BAB SHAMS POLICE STATION  
MOSUL, IRAQ

SUSTAINMENT ASSESSMENT

**SIGIR PA-06-091**  
**APRIL 25, 2007**

SUBJECT: Report on Bab Shams Police Station Sustainment, Mosul, Iraq  
(Report Number SIGIR PA-06-091)

USACE Construction Photo 2 (12 Jun 05)

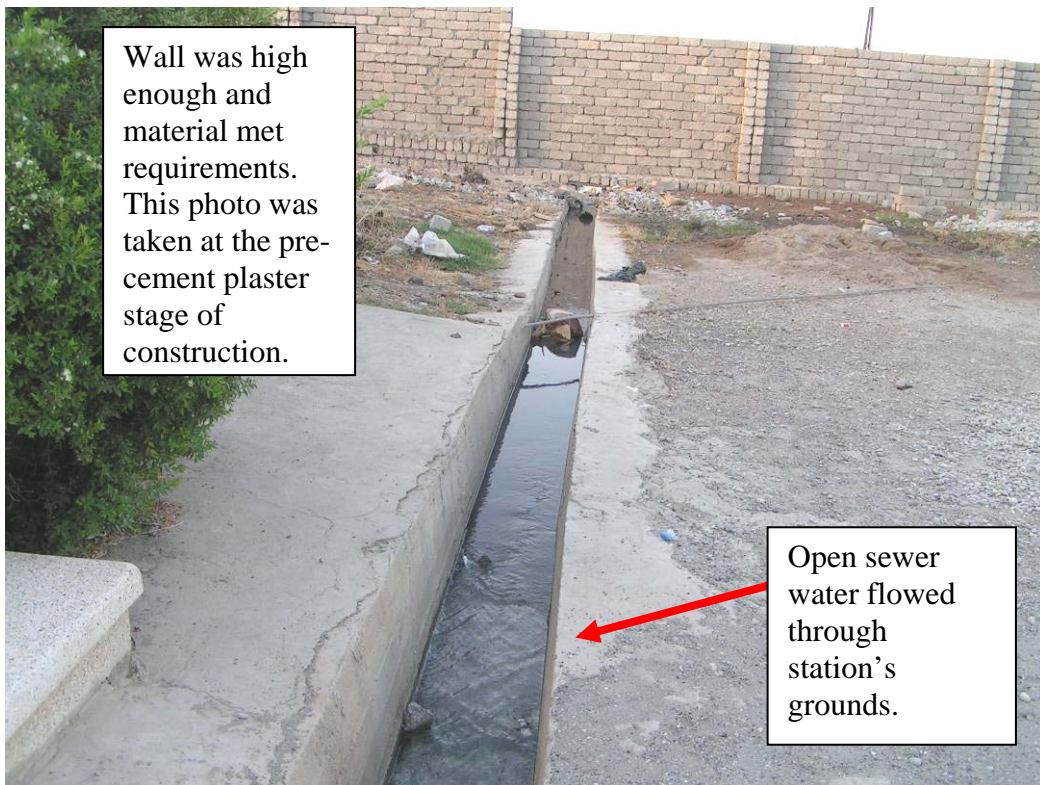
Contrary to SOW requirements, USACE Construction Photos 2 and 3 show that sewer water was not being routed around the perimeter of the police station, but through the station's boundaries. Issues related to the location of the sewer water conveyance system are addressed in the Site Assessment section of this report.

Early on, it was obvious that the contractor was not routing waste water around, but through the police station's boundary.

Site Photo 3.

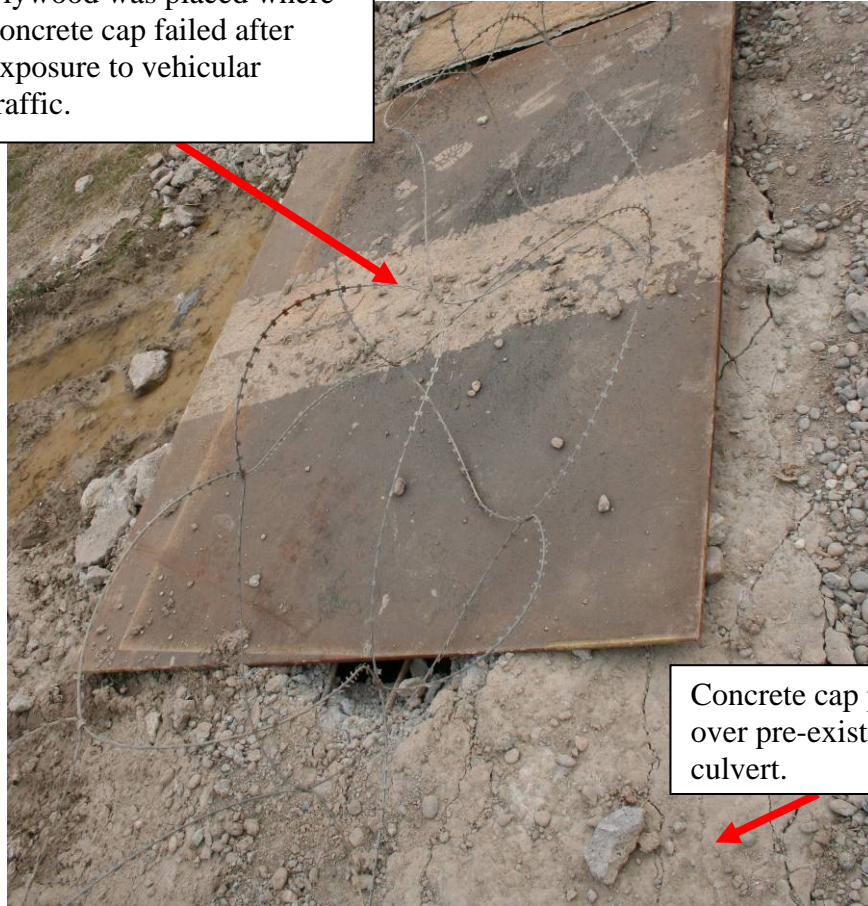
Plywood was placed where concrete cap failed after exposure to vehicular traffic.

Concrete cap placed over pre-existing open culvert.

Site Photo 4.

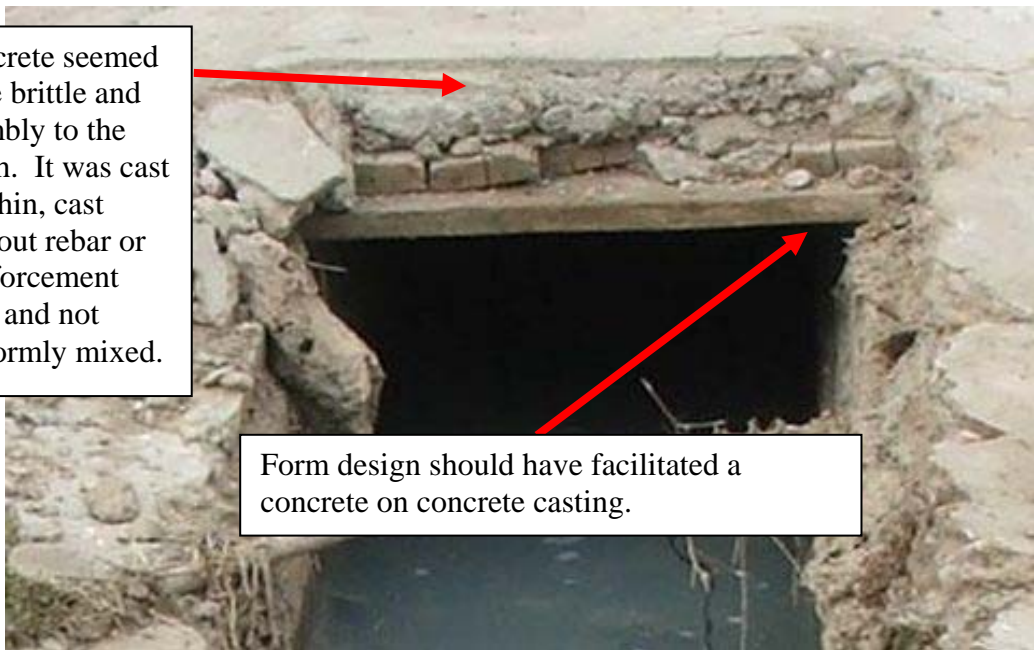
Rather than route sewer water around the perimeter of the station, the contractor merely capped the pre-existing open culvert with concrete. SIGIR inspectors observed that the construction of the concrete cap was poor for a number of reasons and had collapsed under the weight of vehicle traffic (Site Photo 3). As shown in Site Photo 4, the concrete was not uniformly mixed, was cast too thin and was cast without rebar or wire to improve the tensile strength.

In addition, forms should have been constructed in such a manner that the new concrete material would have been placed to touch the culvert's concrete side wall, which is concrete on concrete without wood between the new casting and the existing sidewall. The technique used by the contractor only increased the likelihood of concrete failure. As the wood rots, more stress is placed on the casting as it settles towards a concrete on concrete position.

Concrete seemed to be brittle and crumbly to the touch. It was cast too thin, cast without rebar or reinforcement wire and not uniformly mixed.

Form design should have facilitated a concrete on concrete casting.

**Site Photo 7.**

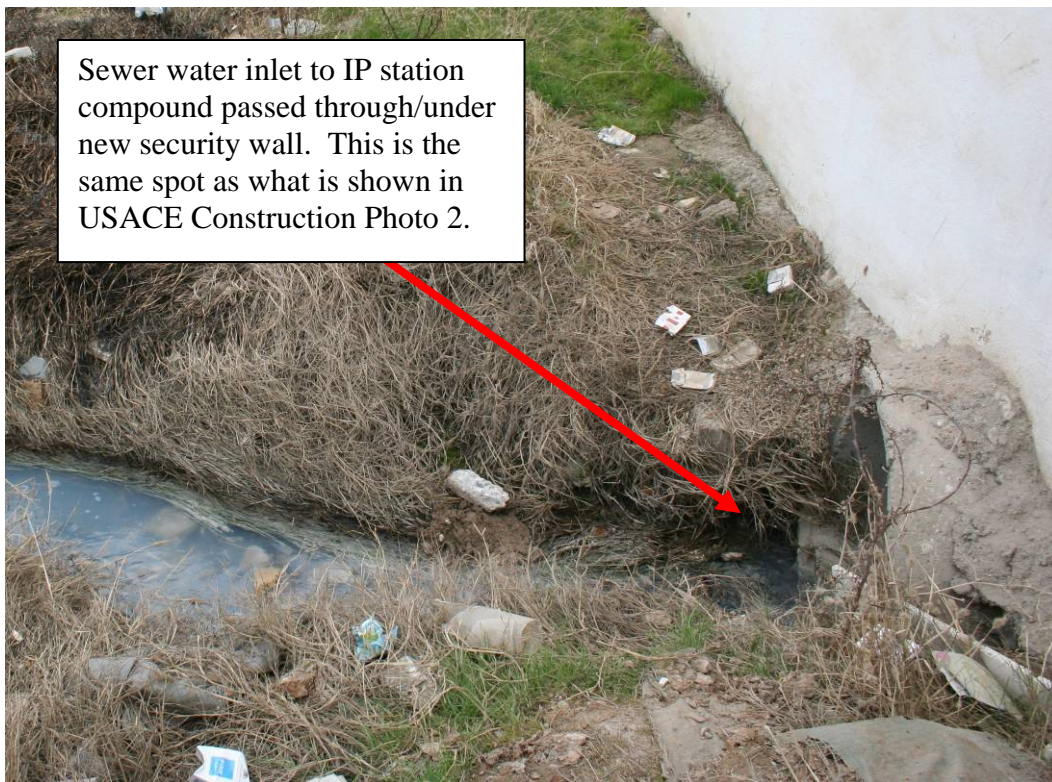
At the time of the site inspection, the conditions were dry and not impacted by recent rains. Nevertheless, Site Photo 7 shows that the open culvert on the high side or half of the compound was running free and able to handle the waste water volume entering the compound that day. However, Site Photo 8 taken at the exit and the open culvert's lowest spot within the confines of the compound shows the open culvert nearly full. It would not take much rain water runoff to create a flooded condition within parts of the IP compound area.

Site Photo 14.

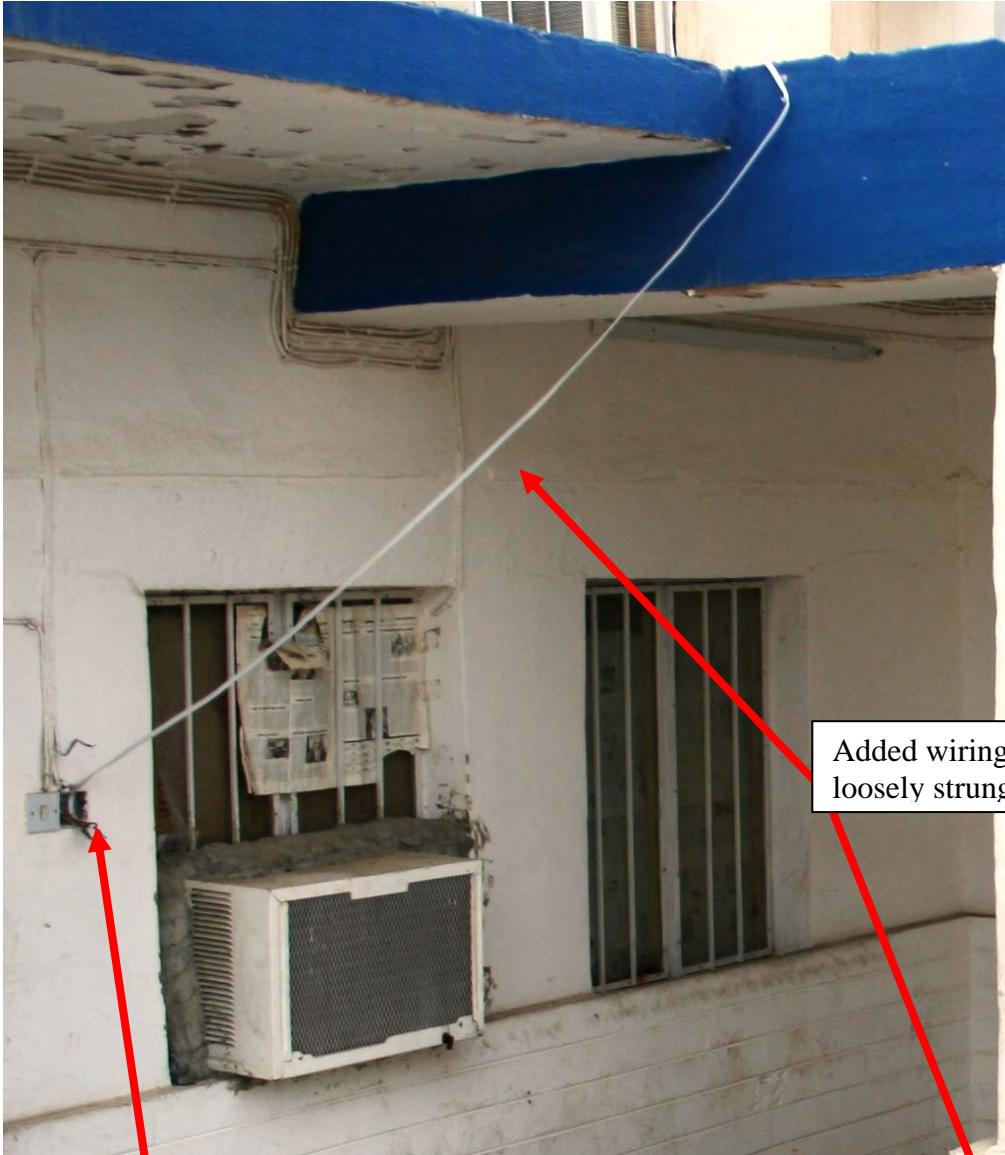
In Site Photos 14 and 15 a typical form of tampering observed by SIGIR inspectors is shown. Site Photo 14 shows how added wiring was loosely strung. Site Photo 15 is a close up and it shows the technique used to “tap into” an existing circuit. Specifically, the existing circuit and load requirement was maintained by twisting the wiring together in order to close the existing circuit. However, the “jury-rigged” wiring that fed a draw point only added to the circuit’s potential load or draw.

Added wiring was loosely strung.

Site Photo 15.

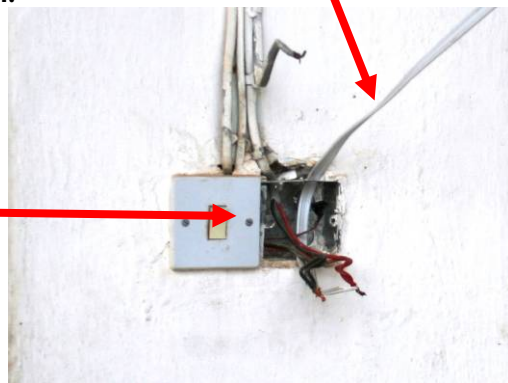
Switch or plug-in was removed and added wiring "tapped into" the circuitry.

Site Photo 16.

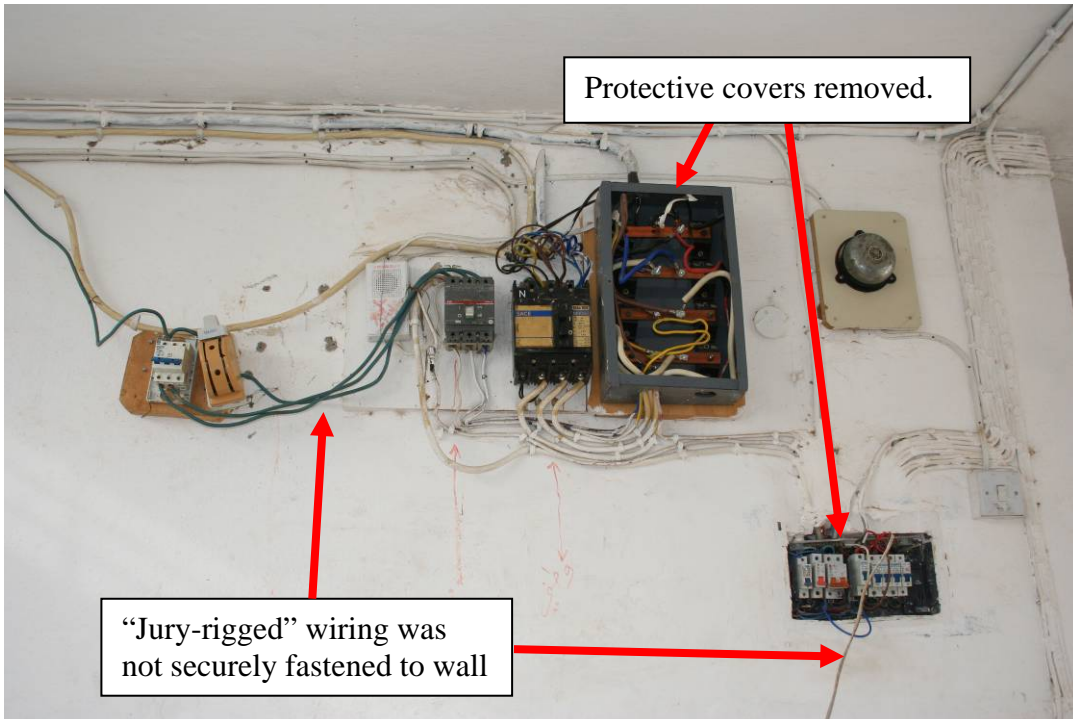
- USACE Construction Photo 5 shows where the contractor added electric system upgrades and properly covered and secured wiring. Conversely, Site Photo 16 taken at the same spot shows where covers were removed and energized system components were exposed. In addition, the photograph shows that “jury-rigged” wiring was added and not secured to walls.
